ADDENDUM

<u>Addendum No.:</u>	3
<u>Project Name:</u>	New Production Well for Parr Road Treatment Plant
<u>Project No.</u>	2018-011-28
<u>Date:</u>	June 3, 2022
<u>To:</u>	All Bidders

SOAKAGE TRENCH DETAIL 1
 SCALE: NTS C-2

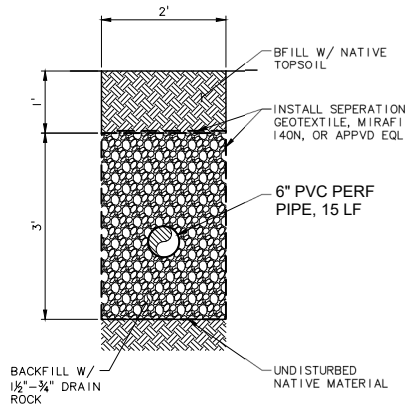
- Add the attached "Soakage Trench" detail to sheet C-16
